ADDENDUM NO. 2

DATE OF ISSUANCE:	April 22, 2024
PROJECT:	2024 Addition and Renovations North Harrison Elementary School 1115 W. Whiskey Run Road Ramsey, IN 47166
OWNER:	North Harrison Community Schools
ARCHITECT'S PROJECT NO.:	23-228.001
ORIGINAL BID ISSUE DATE:	April 03, 2024

SHEET TITLE
WALL SECTIONS

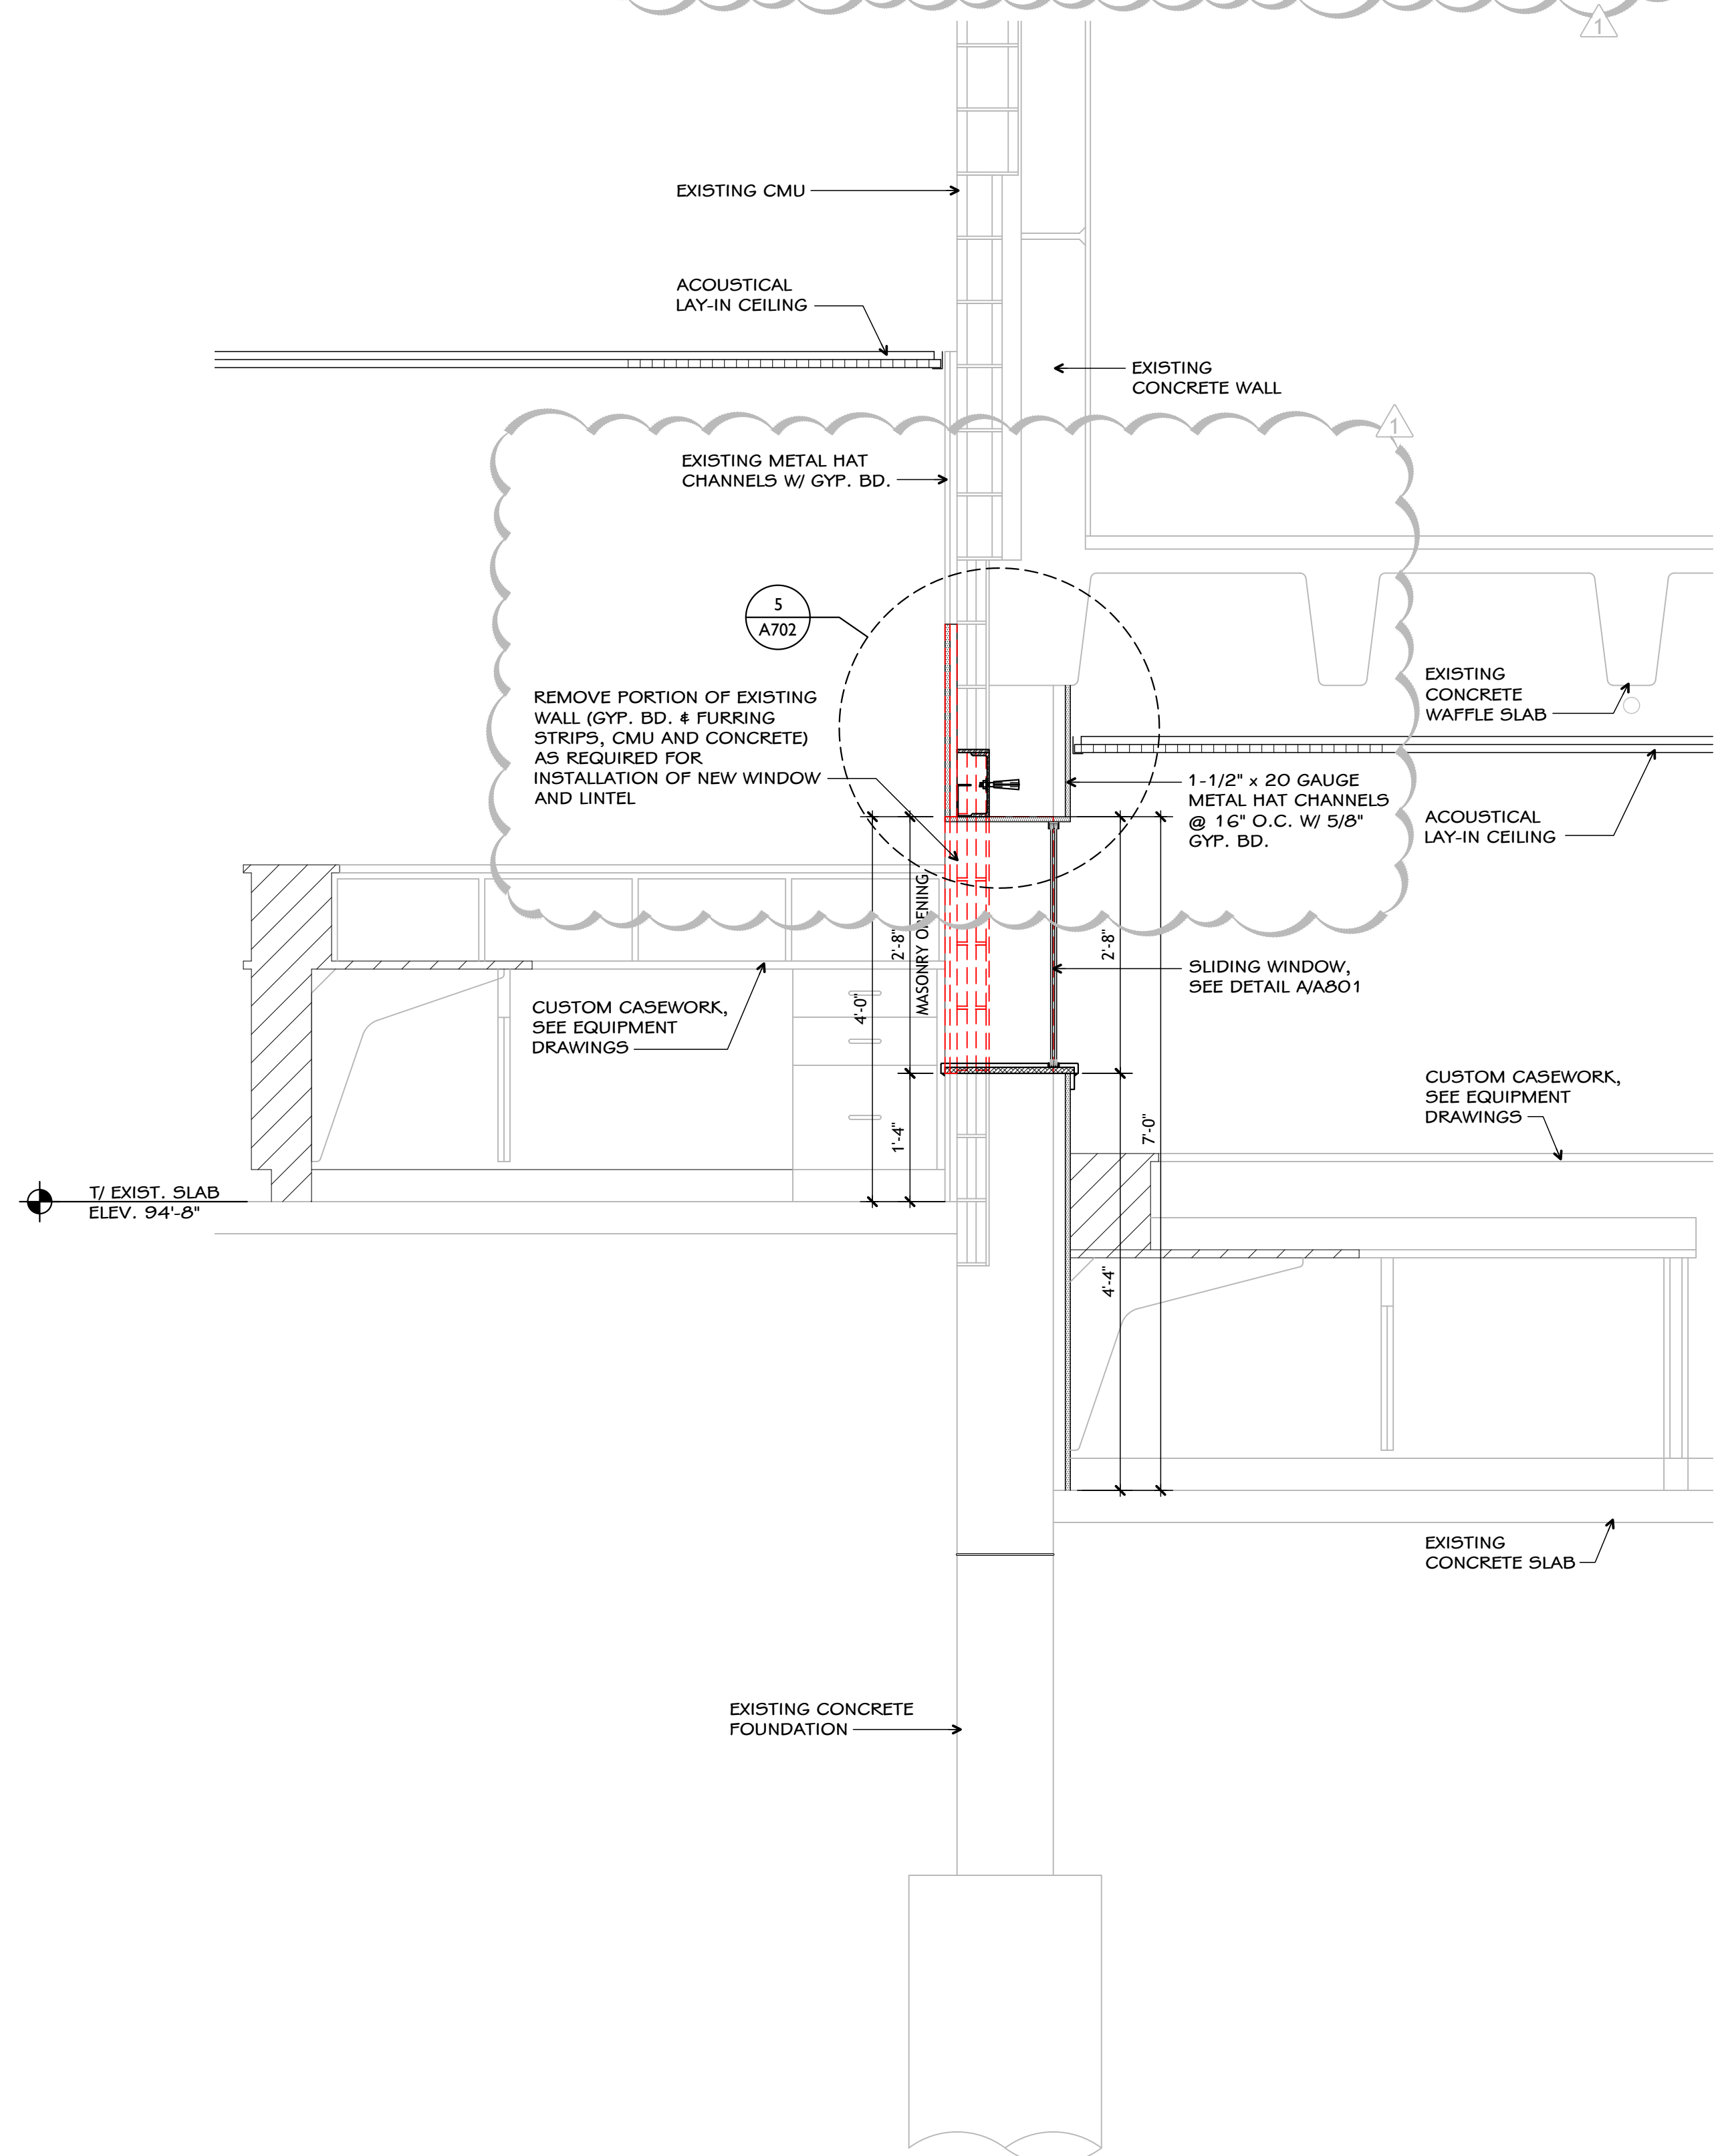
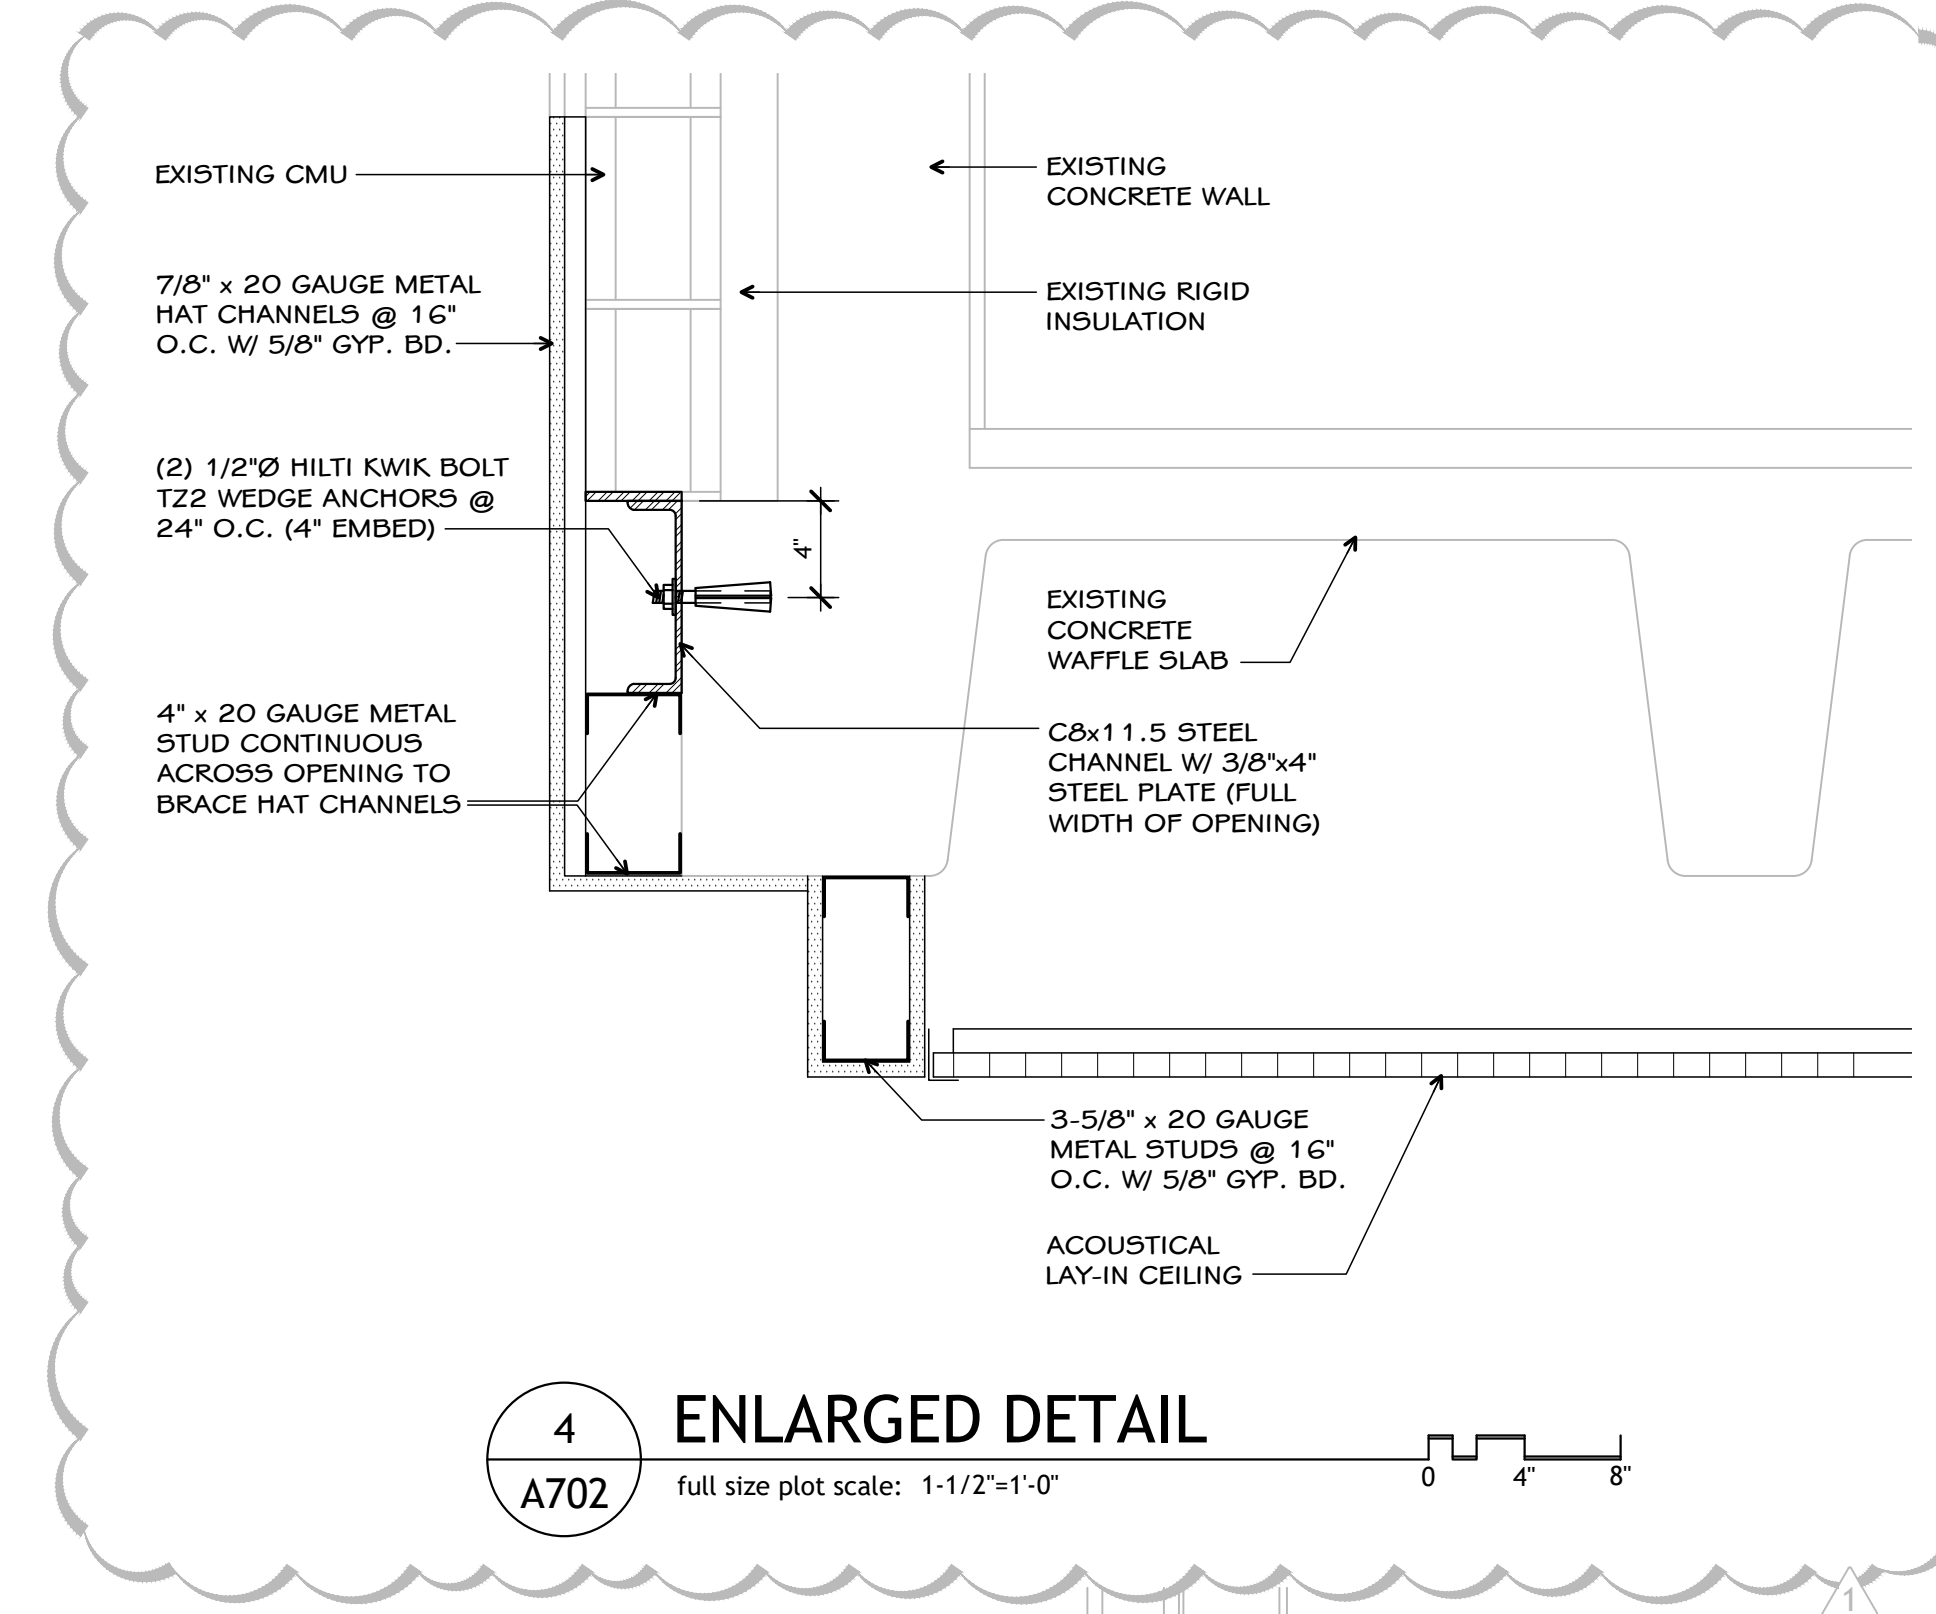
Replace with attached revised Drawing in its entirety; revisions have been clouded for reference. Details added for lintels at openings through existing walls.
